Town of Chilmark Squibnocket Beach and Parking Project
Jim O'Connell Brief

March 6, 2014

RE: Evaluation of the Town of Chilmark's 'Squibnocket Beach Access Parking Lot Relocation and Revetment Removal Project'

Fig 8B. Preliminary Flood Insurance Rate Map (Chilmark)

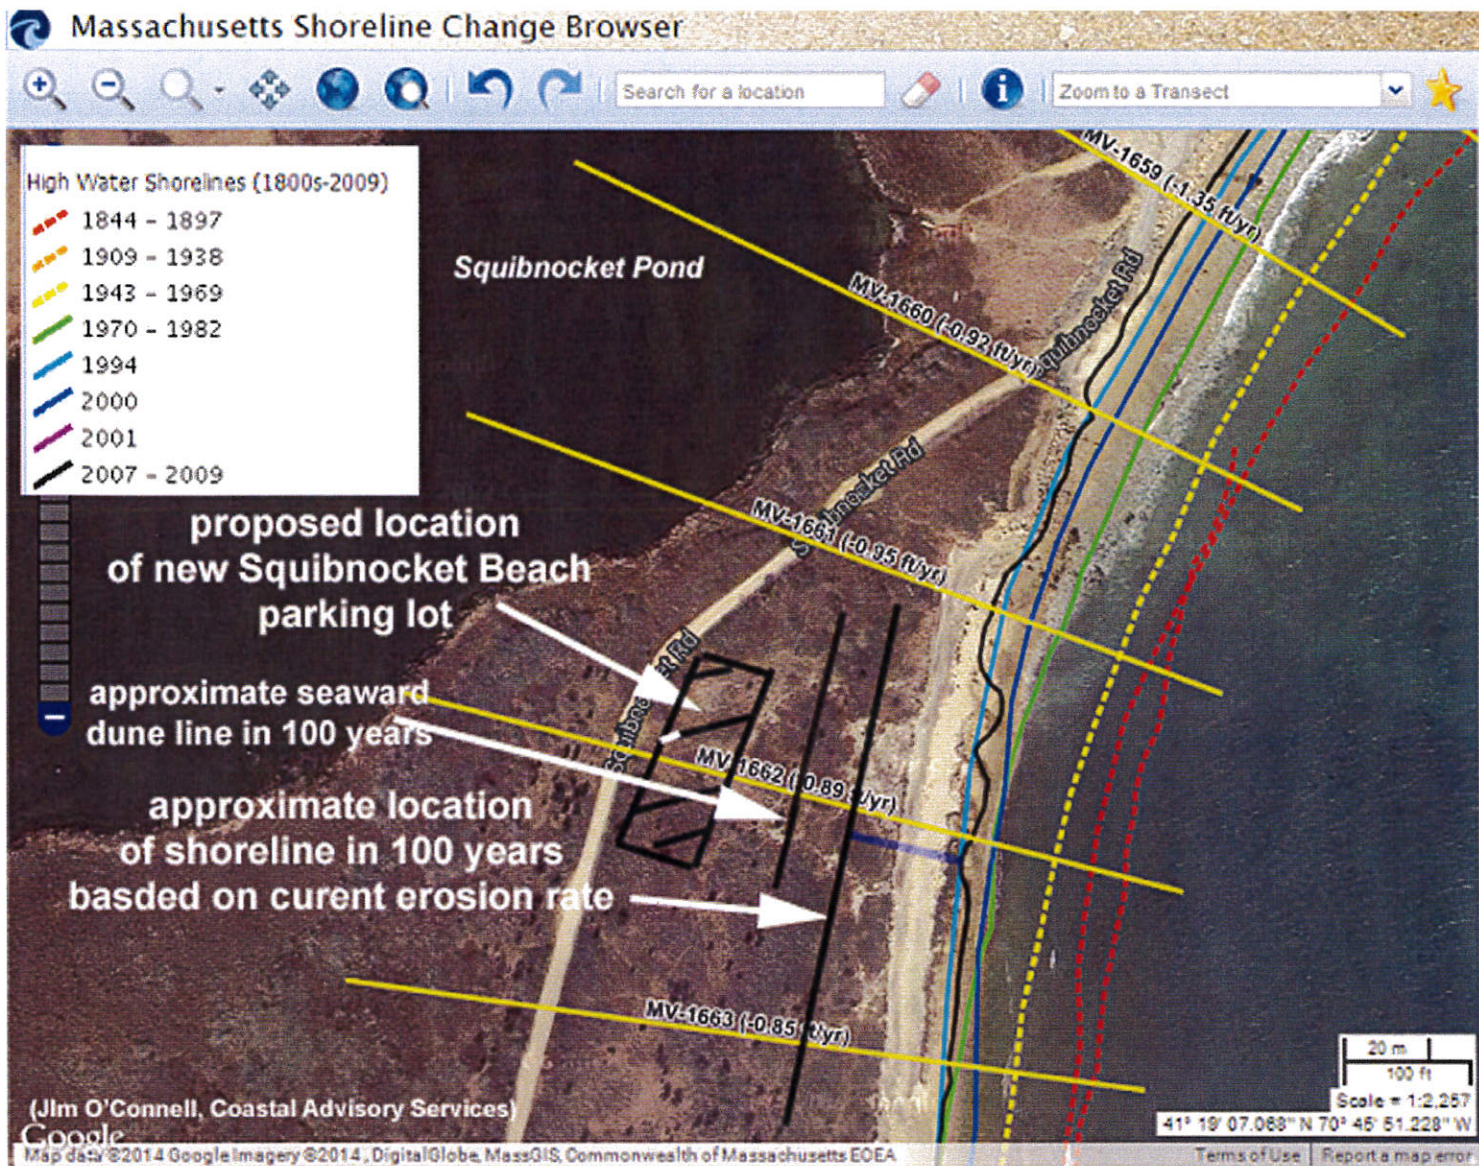
The Preliminary FIRMs (**Figure 8B**), show that most of the existing beach parking lot, all of the fronting beach, and all of the potential lease area, including all of the existing Roadway lie within a FEMA-mapped Velocity Zone, elevation 15' NAVD.

Thus, the Preliminary FIRMs show a higher degree of potential storm wave and flooding inundation relative to the existing FIRMs.

Based in these Preliminary FIRMs, it can anticipated that the proposed new area for the parking lot will remain in a coastal high hazard area, i.e. Velocity Zone, for the foreseeable future. It is odd that the extreme east area of the existing parking lot is mapped 'outside' of the FEMA flood zones. It is obviously subject to storm overwash resulting and coastal storm damage.

Fig 16

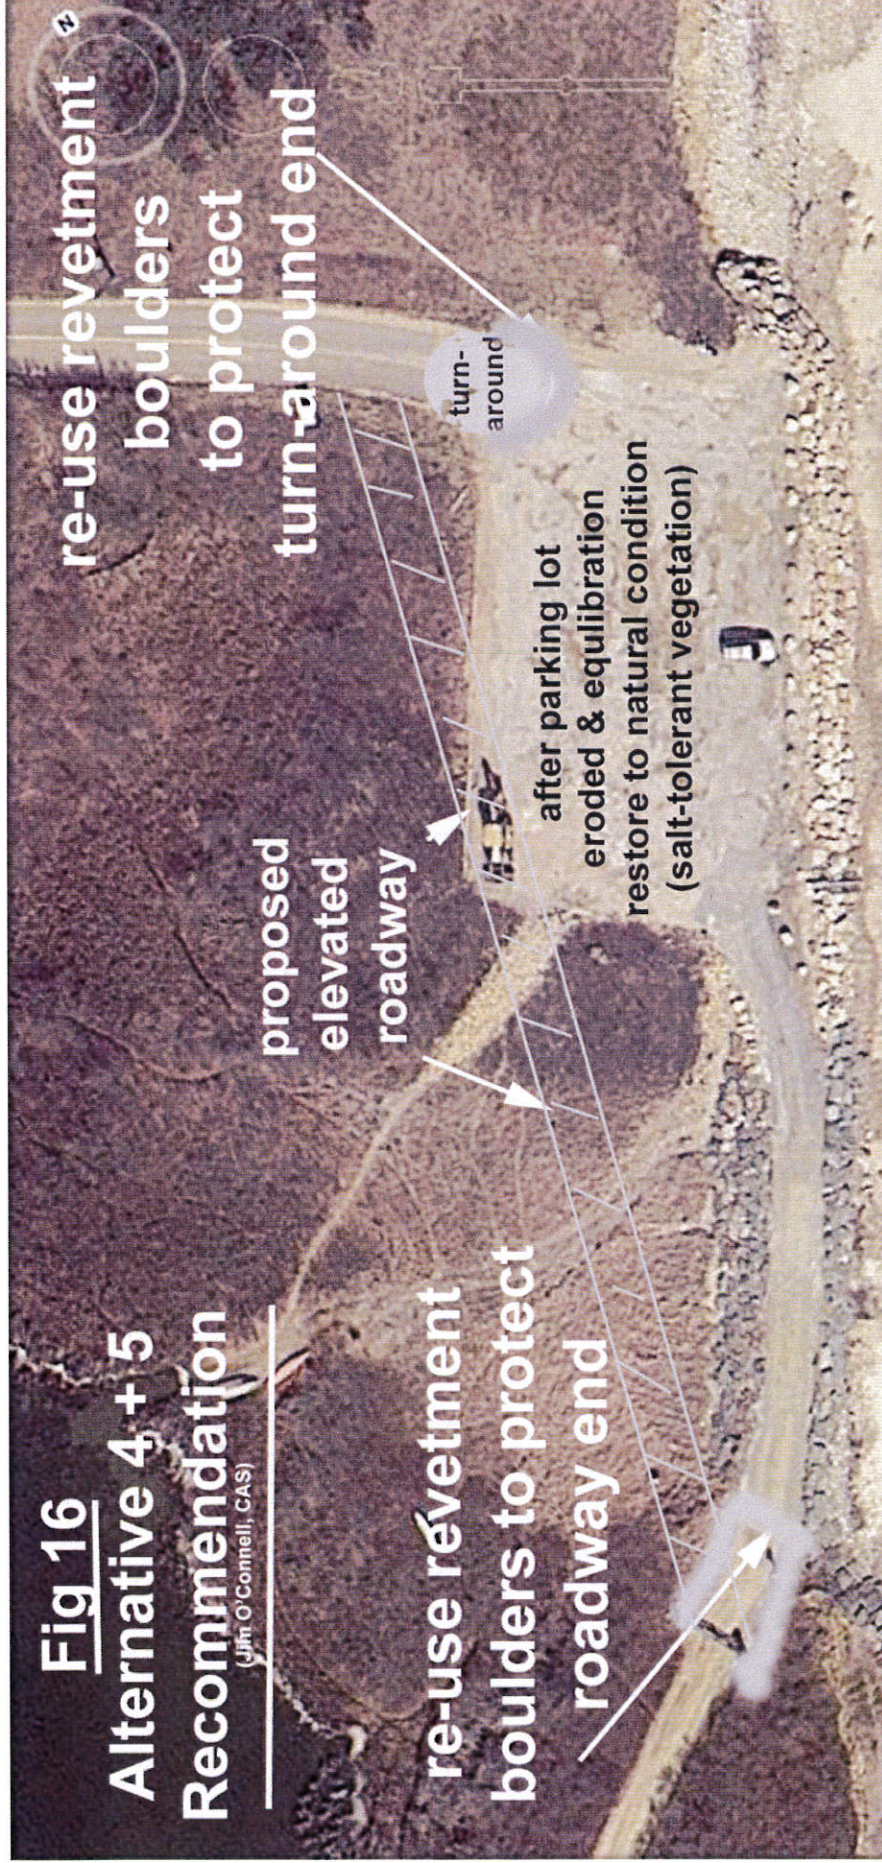
6. Following natural erosion of the underlying parking lot sediments, a coastal dune could be built in the overwash area reducing the frequency of overwash into the Pond, however, overwash is a natural process and not necessarily an adverse impact. The dune would also provide wildlife habitat.

remove only sufficient # boulders to construct
revetments to protect turn-around & roadway end
